Cenovus Energy West White Rose Project (WWRP) Environmental Assessment Drill Cuttings
Amendment – Review Comments – Round Two

Fisheries and Oceans Canada (DFO)

Deposition Mass from 1 drilling operation. Straight red line is Safety Zone boundary. Red circle is the 6.5-0.1 mm thickness boundary (Figure 4.11) from Section 4.2.

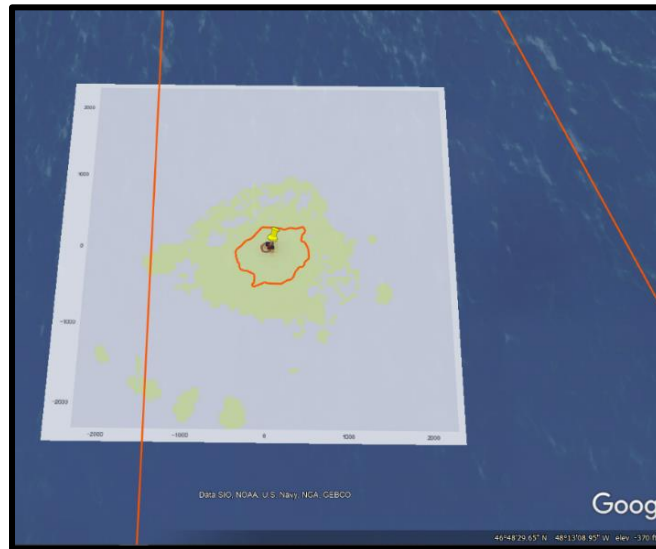
It is possible that drill cutting deposition at 0.1 mm may extend to the boundary or slightly beyond the safety zone after drilling 40 wells (see images below of sections from Figure 6.4, Section 6.2 - page 54 overlain on Google Earth). In the Wood report, considering the mean deposition thickness, 0.7mm extends out to 10-16km (Table 5-2, page 27). This would also be outside of the safety zone. The EA Amendment should be revised to reflect a 40 well program (with consideration of results from the Wood report).
